From: Watkins, Robert
Sent: Wednesday, December 22, 2021 2:04 PM
To: Eric Amtmann <EAmtmann@dgparchitects.com>
Cc: Werner, Jeffrey B <wernerjb@charlottesville.gov>
Subject: December 2021 BAR Decision

Certificate of Appropriateness

BAR 21-04-04
517 Rugby Road, TMP 050046000
Rugby Road-University Circle-Venable ADC District
Owner: Alumni of Alpha Mu, Inc
Applicant: Garrett Rouzer/Dalglish Gilpin Paxton Architects
Project: Alterations to fraternity house

**City of Charlottesville
Board of Architectural Review
Staff Report
December 21, 2021**

Existing Historic Front Porch Column Capital and Entablature

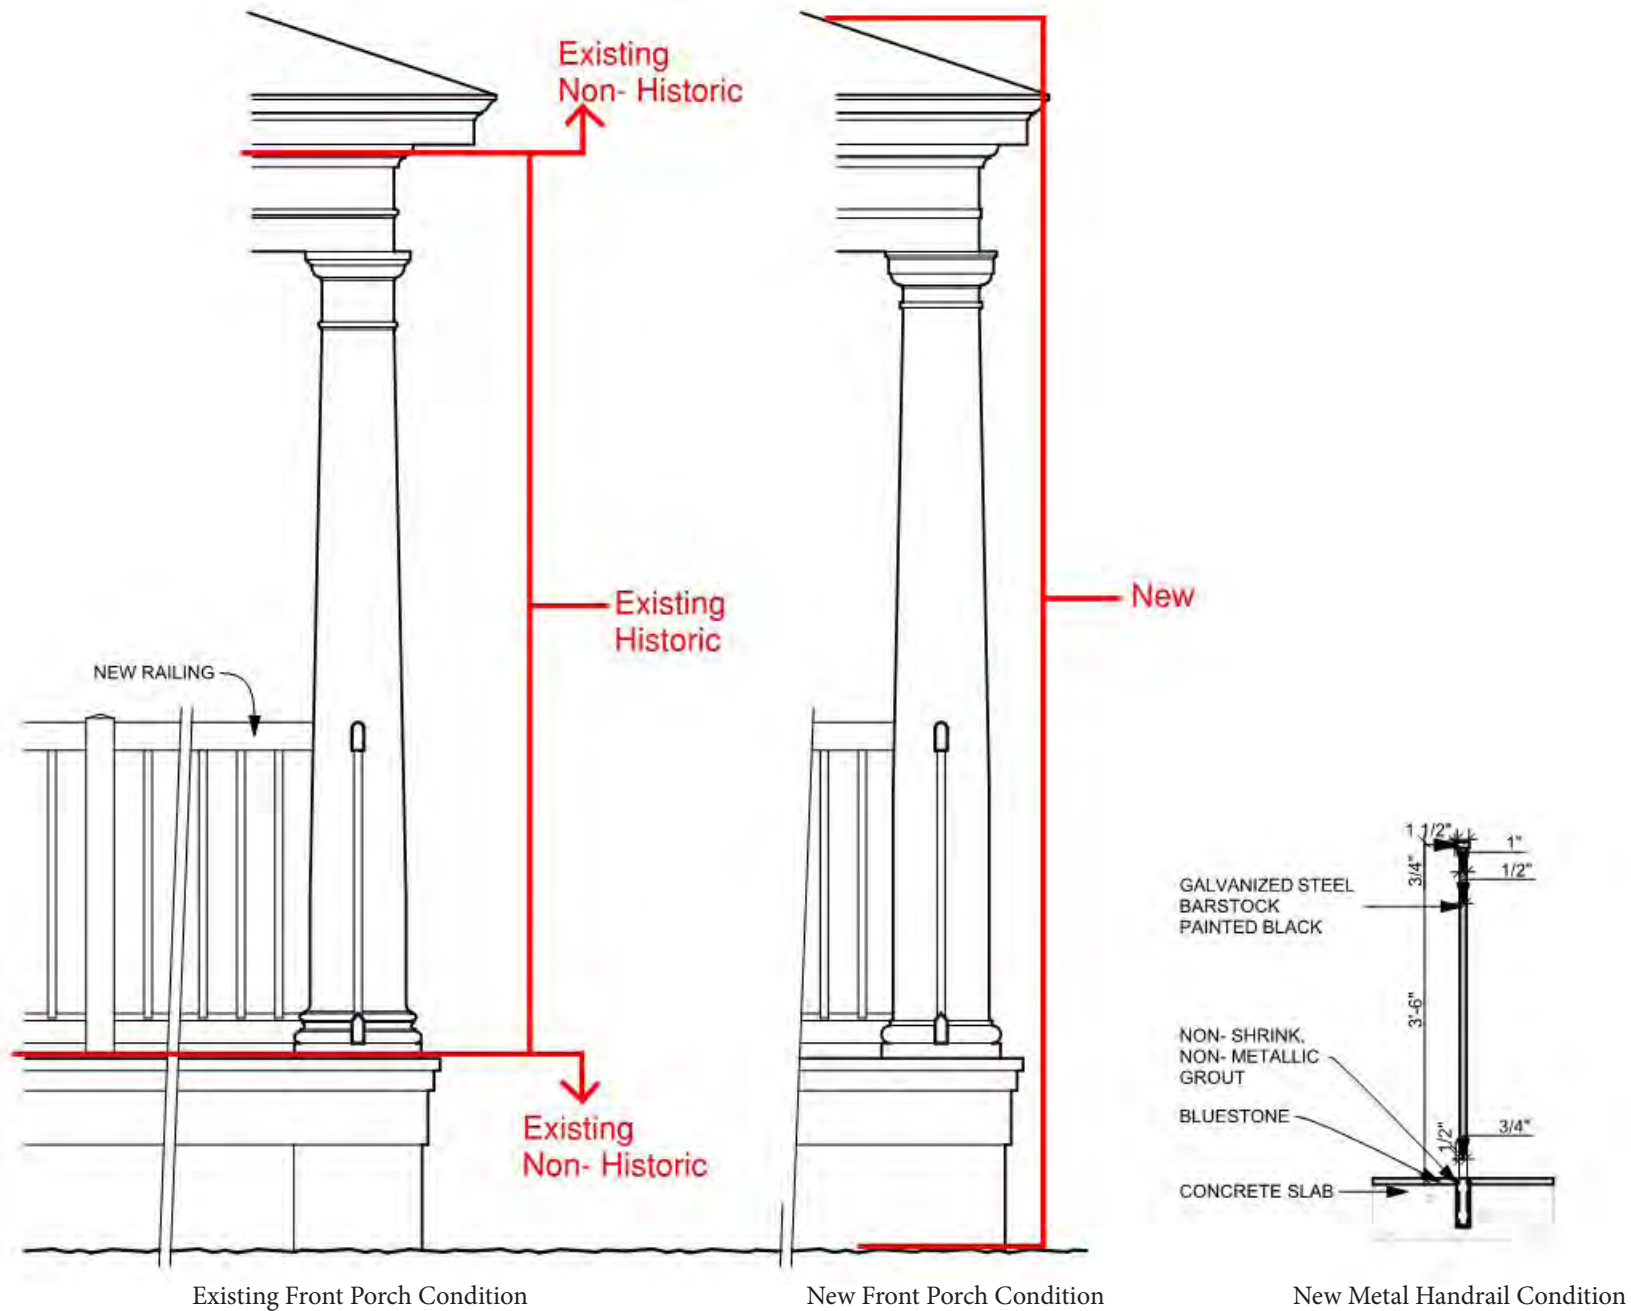
Mr. Mohr – If I was to take the porch drawing literally, the columns seem more slender and the eave more exaggerated. I would be surprised if the roof pitch wasn't flatter. The drawing seems more generic than specific to that detail. Am I right about that? If you look at the entablature in the photo, the eave bears out more projection to it.

Ms. Lewis – I probably would be supportive if the profile of the porch would remain the same. The renderings are a completely different porch. The entablature is 'fussier' than what's there. The 1984 nomination notes that the columns are intonated doric. They seem to have some detail on the top. They are much plainer and thinner than what is proposed here. The railings are not reflective of the existing historic building. I would love to see a lattice in lieu of these. That's probably picking too much up from the windows. I wonder if something else can be done with the railings so that it looks less chunky.
